KSI Karnaphuli Shoes Industries Ltd.(Garments) (Extension)

Plot # G1 & G2, Korean Export Processing Zone, Anowara, Chattogram-4376

21 September 2023

Observations

Discrepancy (Column size) between analysis file and permit drawing

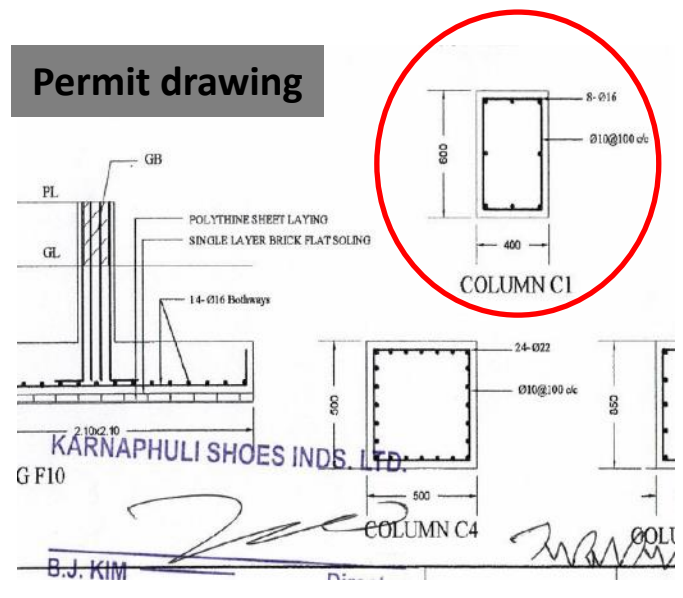
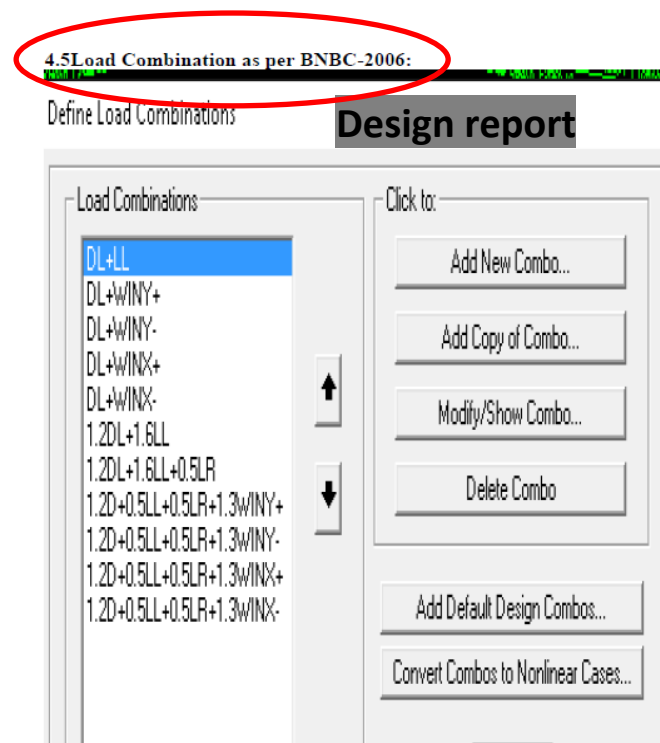
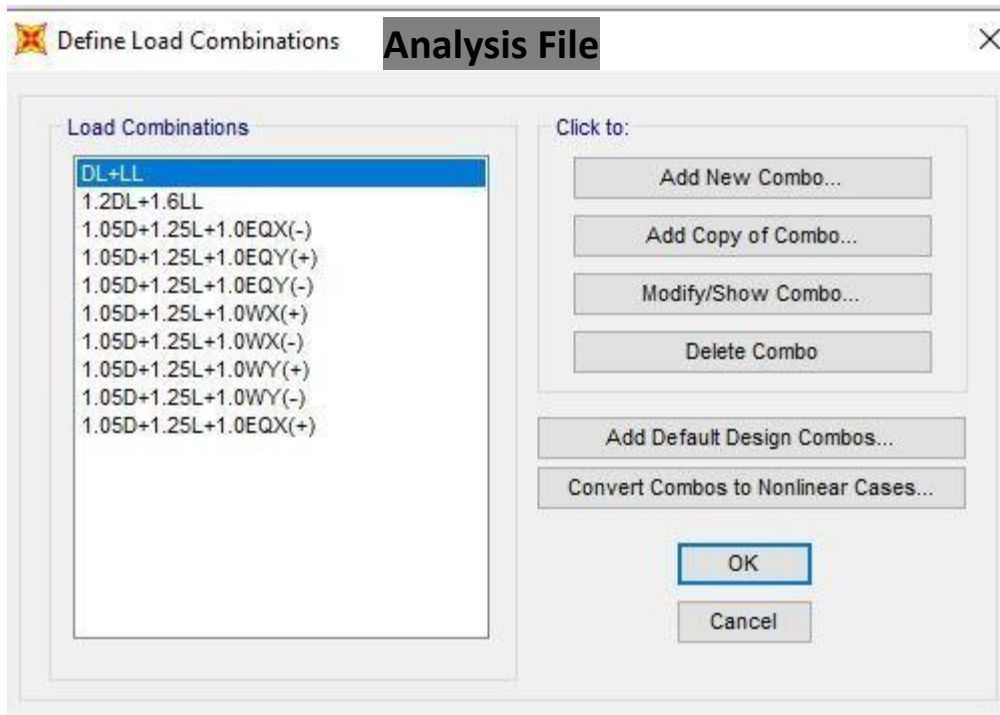
Column size in the analysis file did not match with the permit drawing. Also, rebar tensile strength is considered 72,500 psi but in analysis, 60,000 psi is assigned. Factory is required to revise the design documents and submit to RSC for further review.

Discrepancy in load combination between analysis file and design report

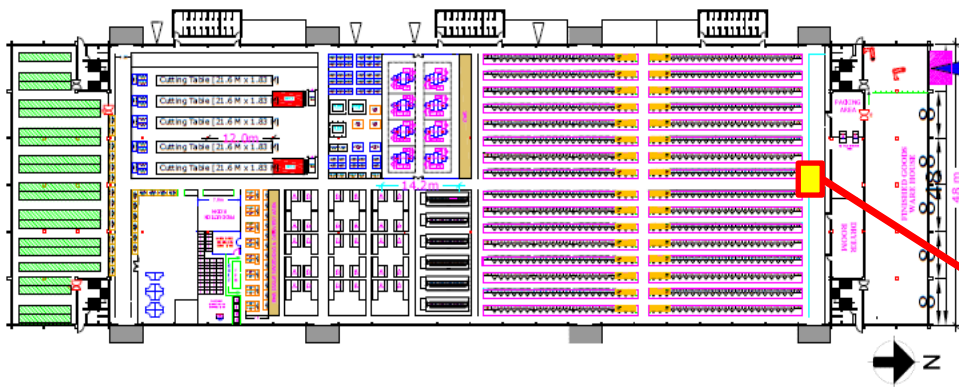
Load combination in analysis file does not match with the provided load combination (BNBC-2006) in design report. Building engineer is required to revise both analysis and design report following one design code.

Column size discrepancy between analysis file and permit drawing

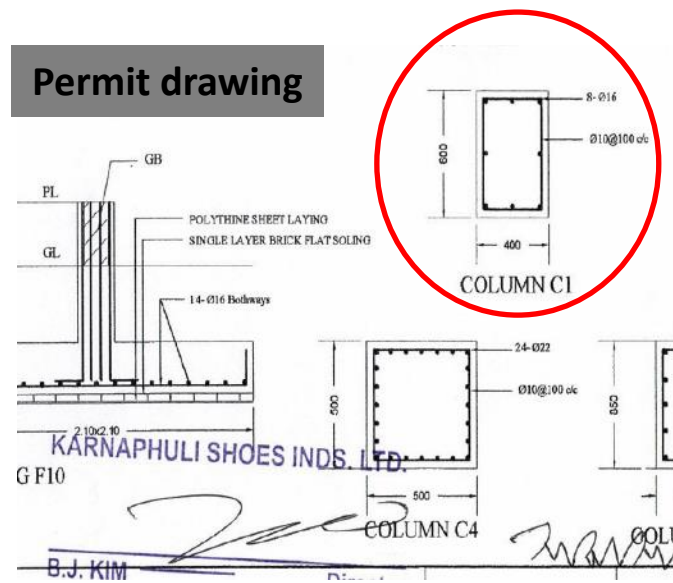
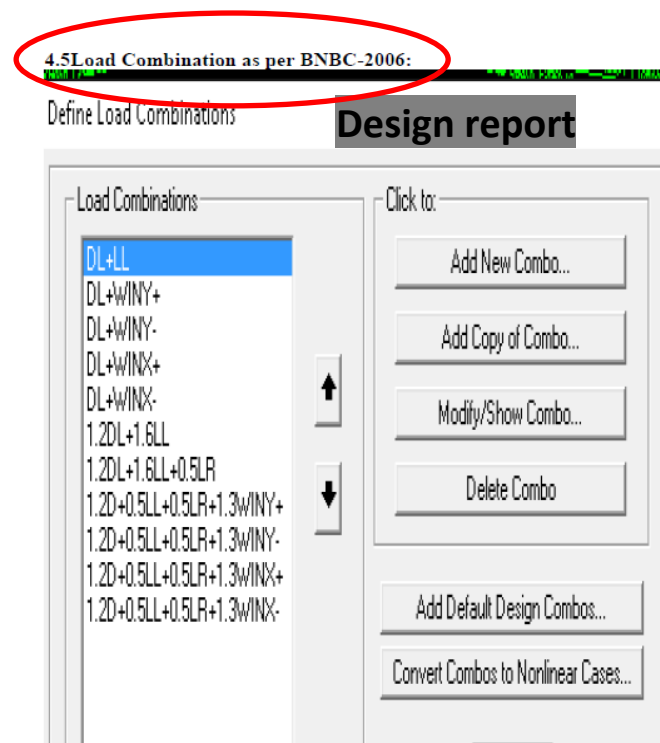
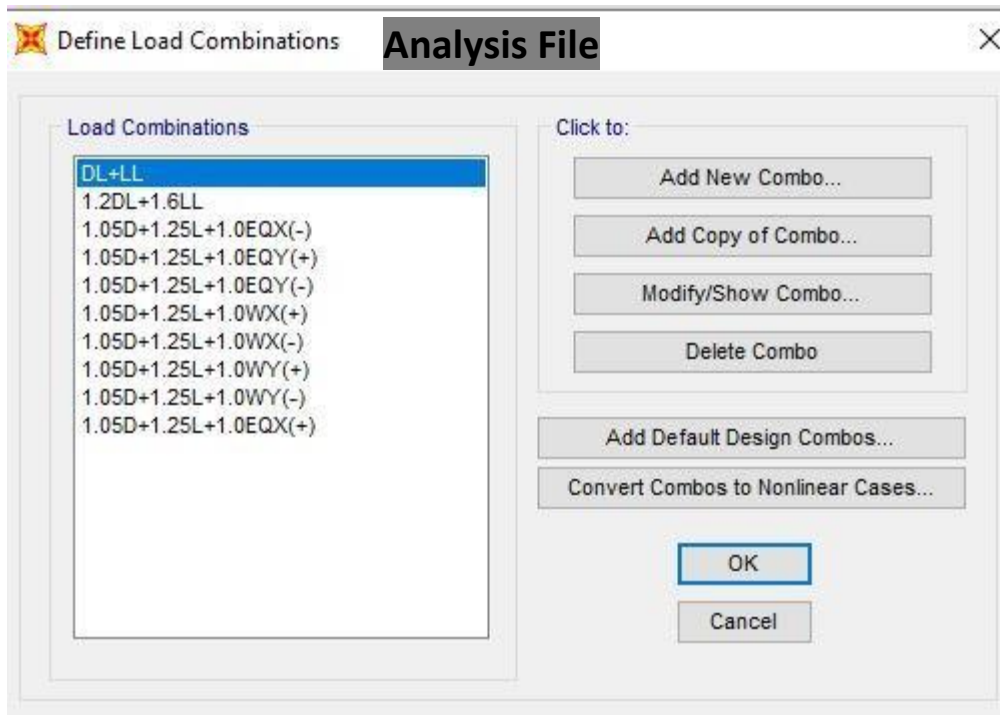
Column size in the analysis file did not match with the permit drawing. Also, rebar tensile strength is considered 72,500 psi but in analysis, 60,000 psi is assigned. Factory is required to revise the design documents and submit to RSC for further review.

Discrepancy in load combination between analysis file and design report

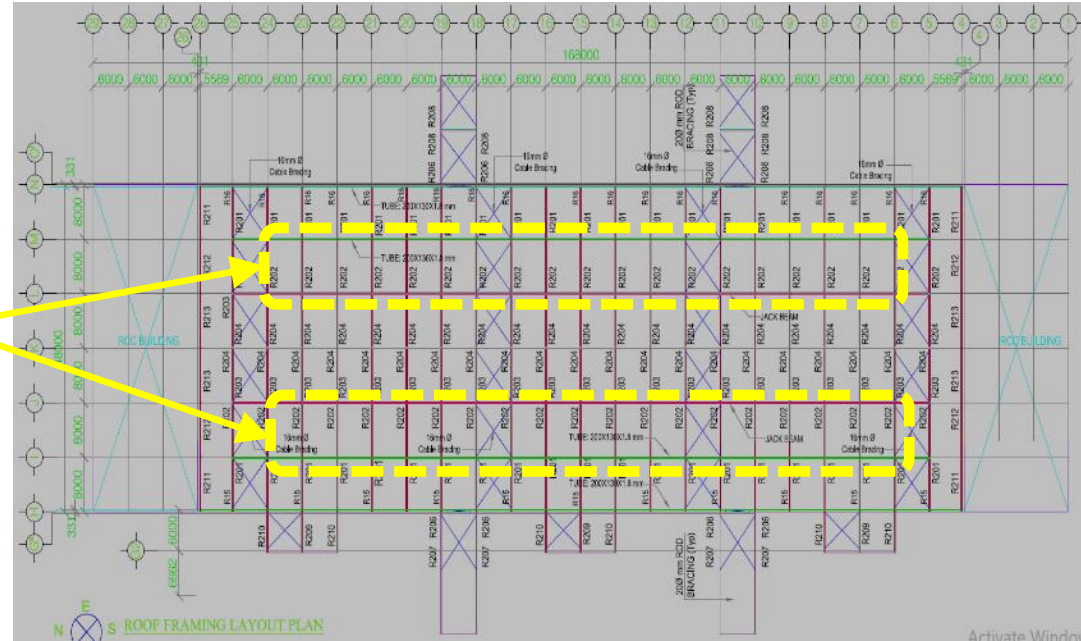
Load combination in analysis file does not match with the provided load combination (BNBC-2006) in design report. Building engineer is required to revise both analysis and design report following one design code.

On site bracings does not match with the bracing layout of as-built drawing

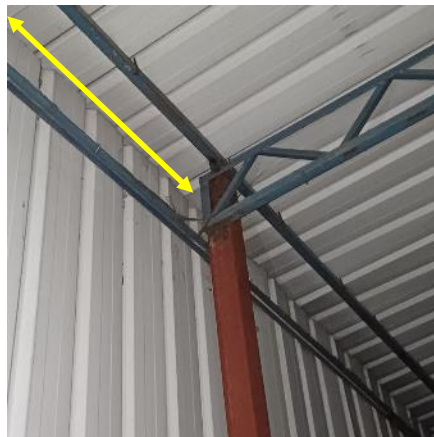
During inspection, bracings were found on site which were not shown in the bracing layout of as-built drawing. Factory engineer is required to survey the whole structure and update the as-built drawing. Also, Building engineer is required to update the design document in compliance with section 1.9.1 as per BNBC 2006.

Lack of lateral stability and inadequate connection

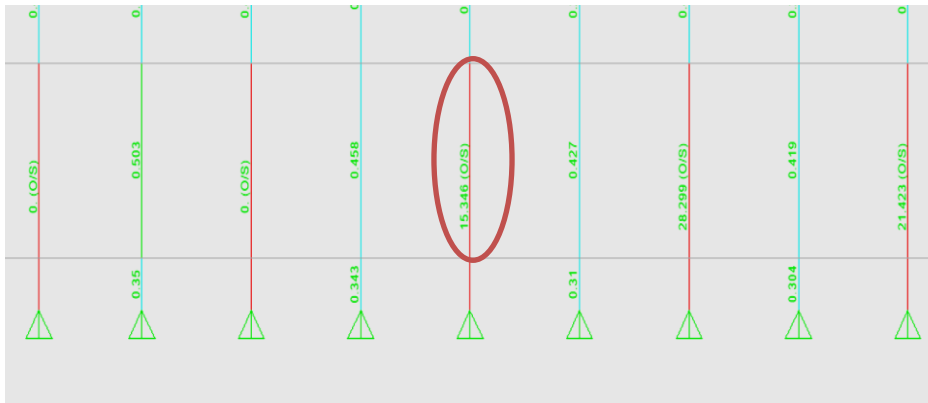
Connection of steel truss members to steel columns were appeared to be inadequate. Factory engineer is required to check the connection adequacy for uplift forces as part of EA.

Also, lack of lateral stability was found in adjacent steel sheds (Temporary garbage store, store room and material store). Building engineer is required to check the lateral stability of the structures.

Overstress column (RCC) in FEA model

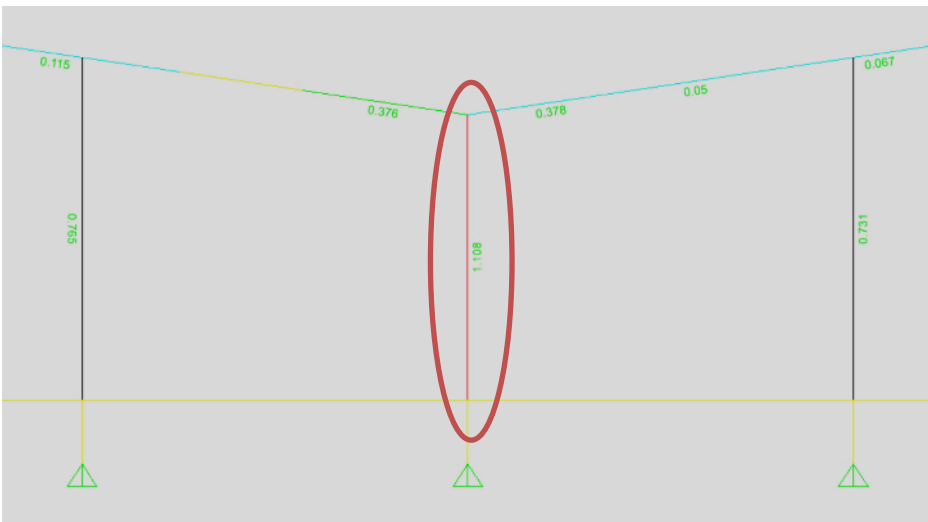
A design report was available on site which indicate stone chips was considered for concrete design. But brick chips was found on site. In FEA model RC OHWT load was not assigned and some overstressed columns were also observed both in RC and steel part. Building engineer is required to update the FEA model, design report and other requirements as per BNBC.

Load plan not comply with BNBC requirements

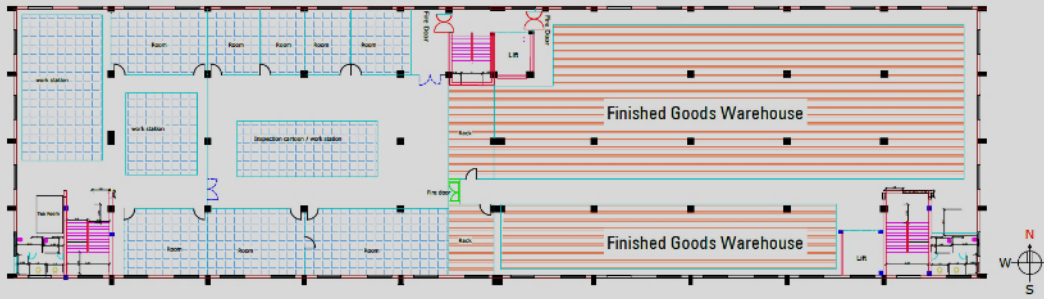
The first and second floor of south part of the building is allotted for storage. As per BNBC, the minimum floor live load for storage is 6 kN/m² (126 psf). But the first and second floor of the building is designed for 3 kN/m² live loads. Factory engineer is required to revise the load plan and related design documents based on BNBC requirement.

Lack of lateral stability system

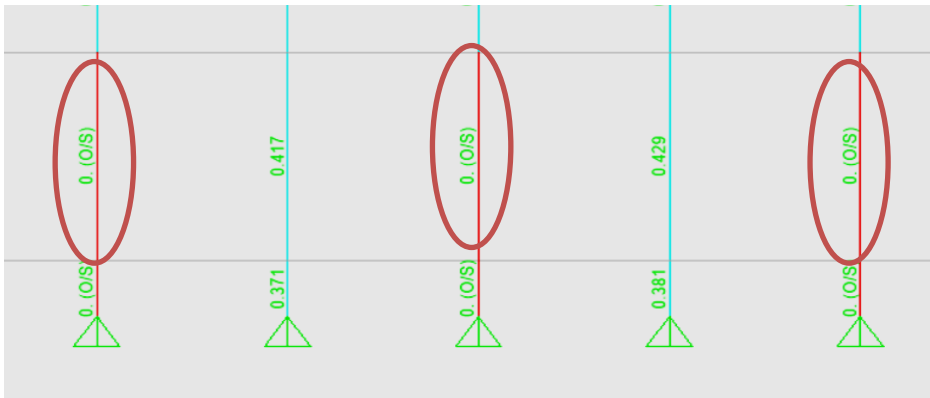
No bracing system was observed. Also, the connection between steel column and pedestal was improper. The building engineer is required carry out Engineering Assessment (EA) to check the connection & lateral stability of the structure and suggest proper remedial actions accordingly.

Overstress column (RCC) in FEA model

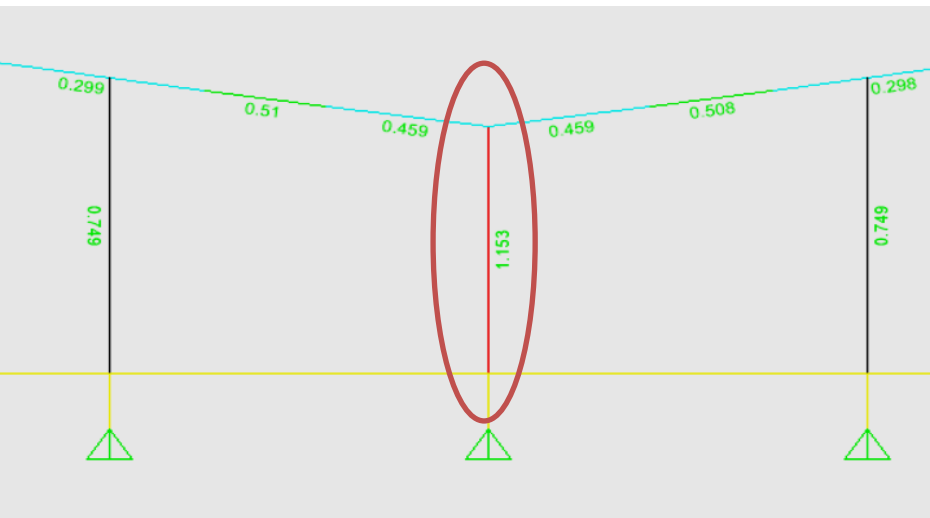
A design report was available on site which indicate stone chips was considered for concrete design. But brick chips was found on site. In FEA model RC OHWT load was not assigned and some overstressed columns were also observed both in RC and steel part. Building engineer is required to update the FEA model, design report and other requirements as per BNBC.

Load plan not comply with BNBC requirements

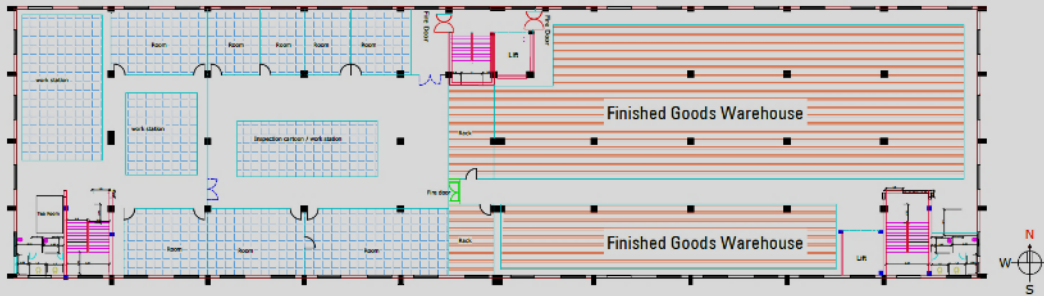
The first and second floor of south part of the building is allotted for storage. As per BNBC, the minimum floor live load for storage is 6 kN/m² (126 psf). But the first and second floor of the building is designed for 3 kN/m² live loads. Factory engineer is required to revise the load plan and related design documents based on BNBC requirement.

Lack of lateral stability system

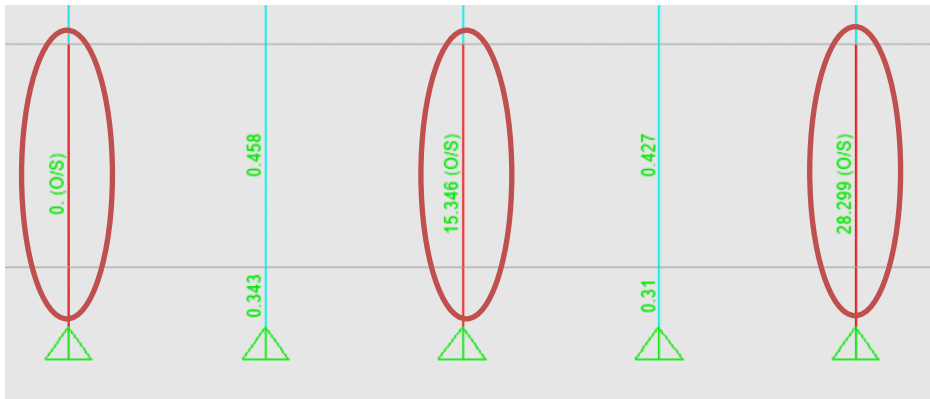
No bracing system was observed. Also, the connection between steel column and pedestal was improper. The building engineer is required carry out Engineering Assessment (EA) to check the connection & lateral stability of the structure and suggest proper remedial actions accordingly.

Overstress column (RCC) in FEA model

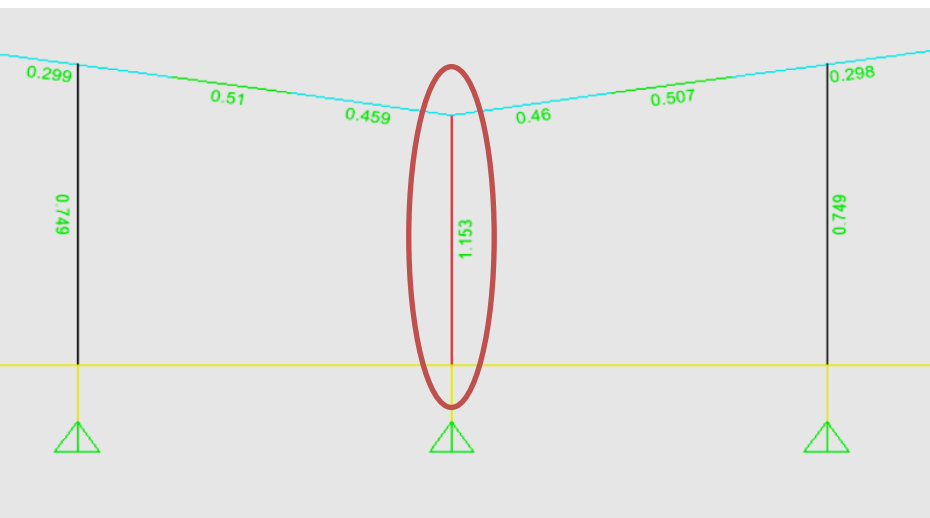
A design report was available on site which indicate stone chips was considered for concrete design. But brick chips was found on site. In FEA model RC OHWT load was not assigned and some overstressed columns were also observed both in RC and steel part. Building engineer is required to update the FEA model, design report and other requirements as per BNBC.

Load plan not comply with BNBC requirements

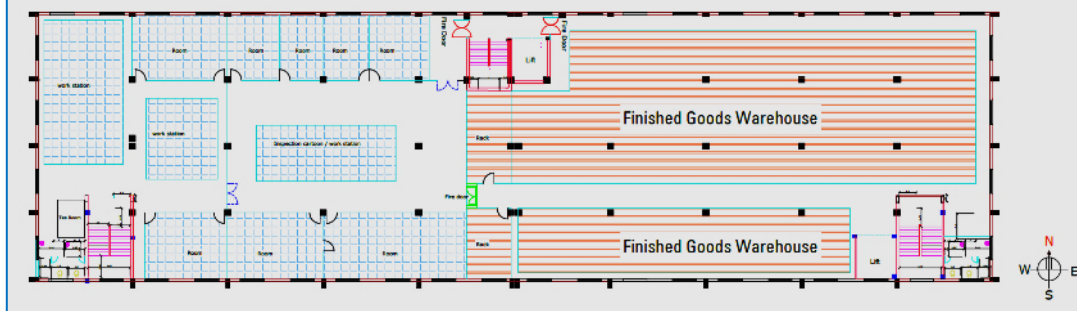
The first and second floor of south part of the building is allotted for storage. As per BNBC, the minimum floor live load for storage is 6 kN/m² (126 psf). But the first and second floor of the building is designed for 3 kN/m² live loads. Factory engineer is required to revise the load plan and related design documents based on BNBC requirement.
